Date: May 12,2003
To: Holders of DIRECTION 2275665
Subject: **DIRECTION 2275665**
Enclosed are the REV 6 update pages.

Direction 2275665

Revision 6

Signa[®] Ovation Pre-Installation

MAGNET MINIMUM DOOR/HALLWAY DIMENSIONS 90° TURN
ILLUSTRATION 2-6

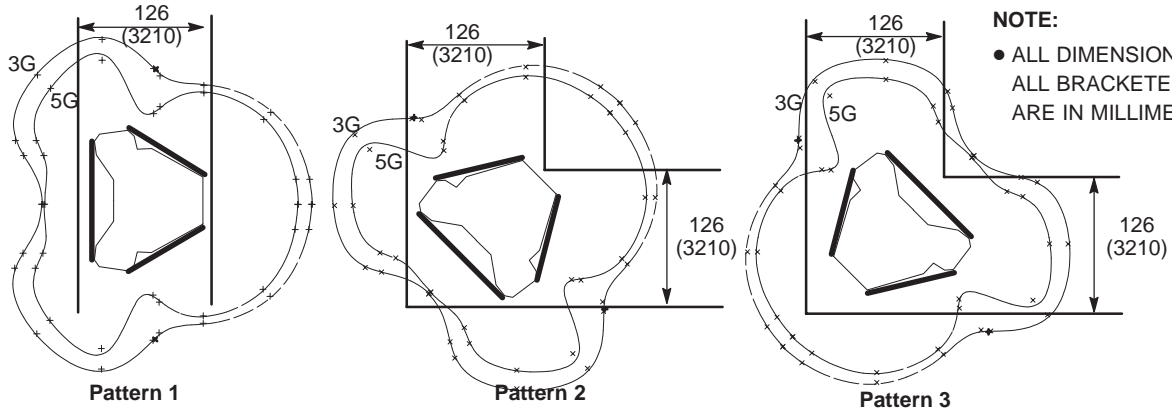
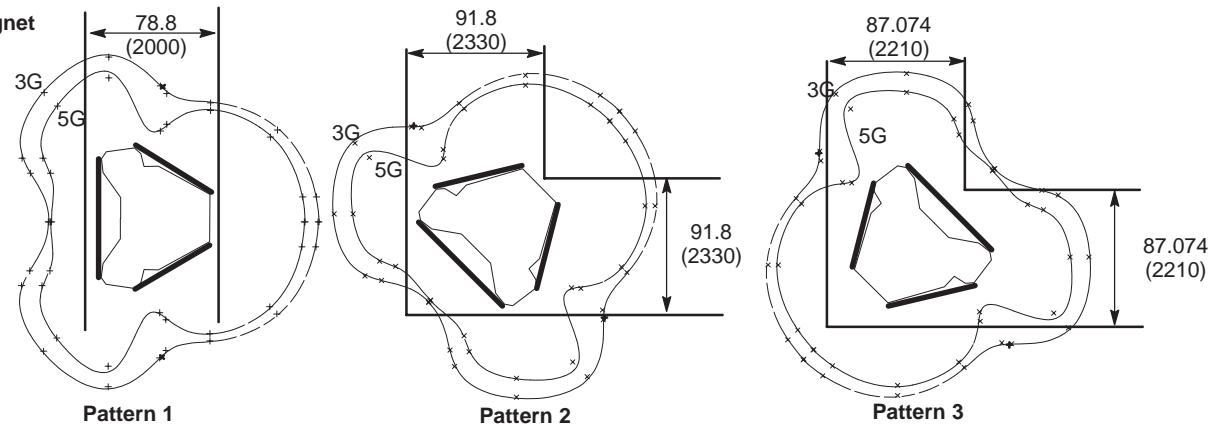
- P2-12: Added Note about YD Magnet Minimum hallway. P2-31: Added New Power cabinet minimum ceiling height.

NOTE: After the YD magnet has been jacked up, put on roller dollies and the jacks removed, same hallway size as a YC magnet (2000mm wide) may be used.
